Re: Additional Information Relevant to Case 13865
Application for a Permit to Drill and Operate an Injection Well
Targa Midstream Services Limited Partnership
South Eunice Compressor Station, Lea County, New Mexico

RE: ADDITIONAL INFORMATION RELEVANT TO CASE 13865 (TARGA REQUEST FOR AUTHORIZATION TO INJECT IN SECTION 27, T22S, R37E; LEA COUNTY, NEW MEXICO) IN RESPONSE TO ISSUES RAISED BY NMOCD ENVIRONMENTAL BUREAU

Max Range vs Bearing

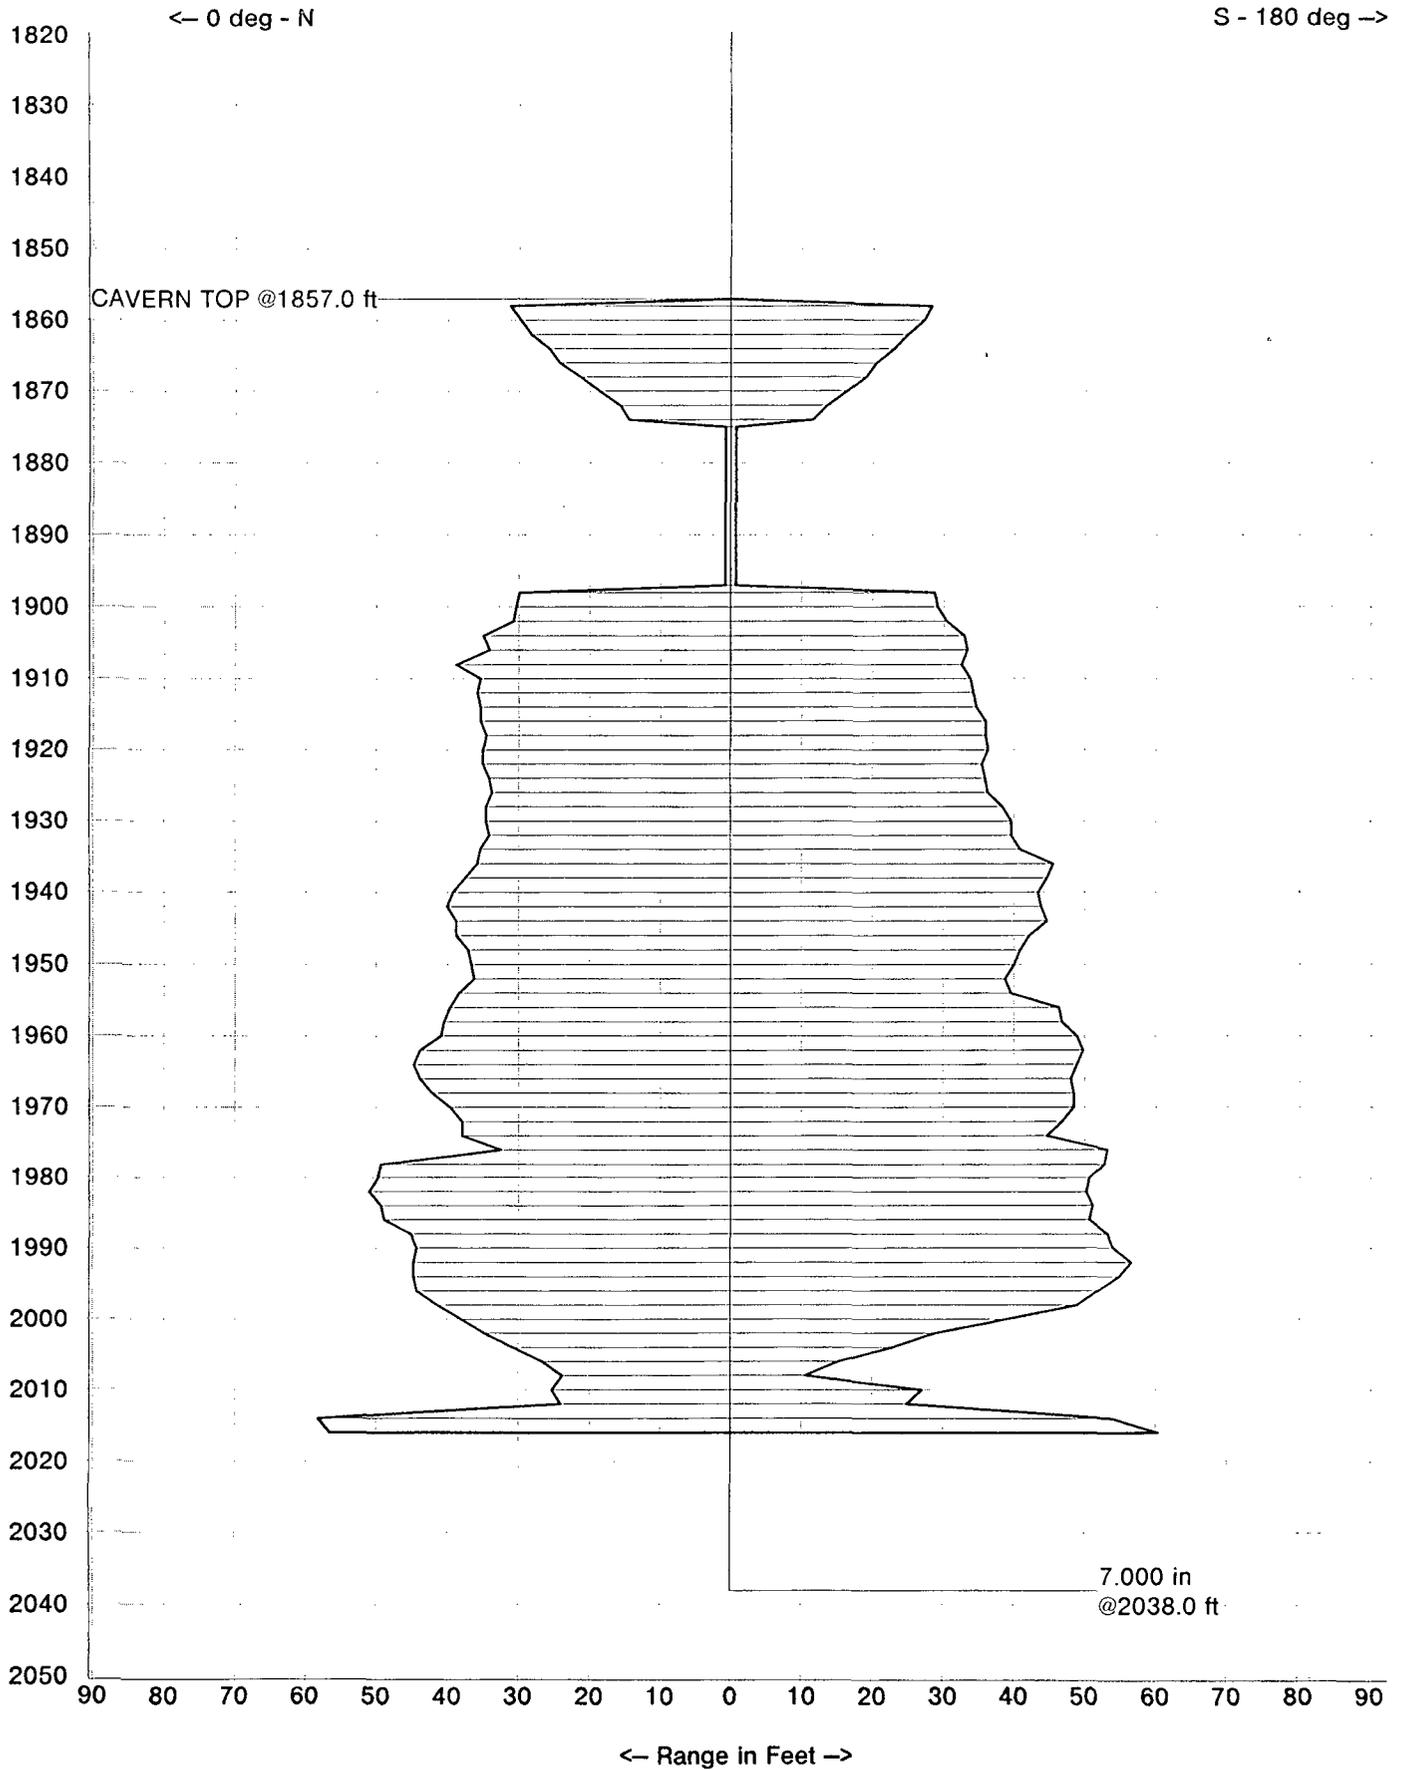
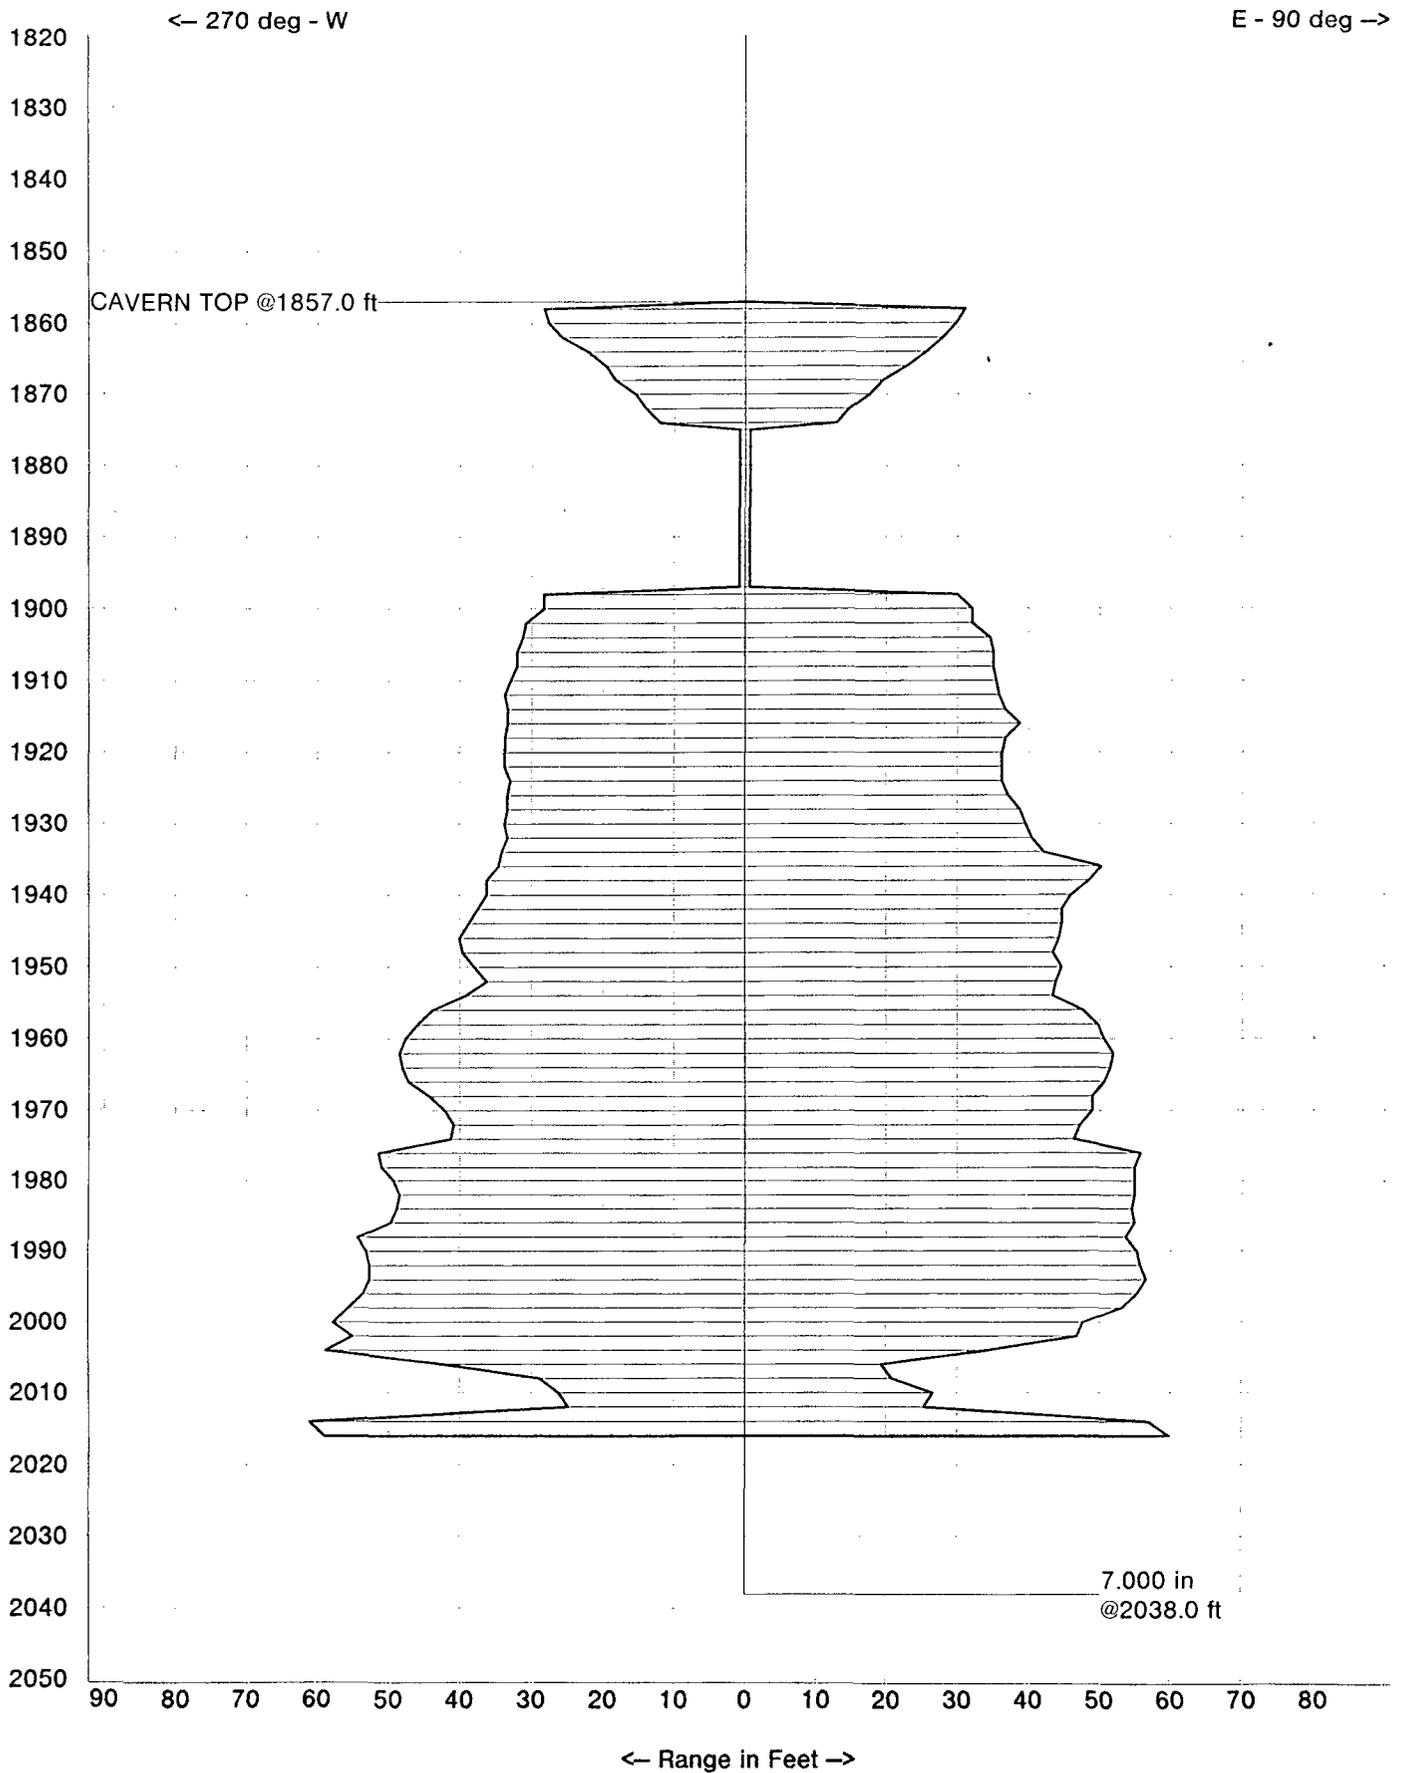
On July 12, 2007 Gray Wireline returned with Sonarwire, Inc. of Abita Springs, LA. 70420, to conduct a sonar survey. The survey was witnessed by Mr. Leonard Lowe of the NMOCD, Santa Fe and myself. The sonar indicated a circular cavern with a maximum radius of 61.6 feet. See enclosed documents titled Max Range vs Bearing, Vertical Cross Section (north to south), and Vertical Cross Section (east to west).

The survey identifies the cavern radius to be approximately 20 yards in the direction of the proposed AGI drill site. The horizontal distance separating the #4 well and the proposed AGI well site is approximately 170 yards. With the approximately 150 yards horizontal distance separating these borings Targa feels there is no potential impact from #4 well on the proposed drilling location.
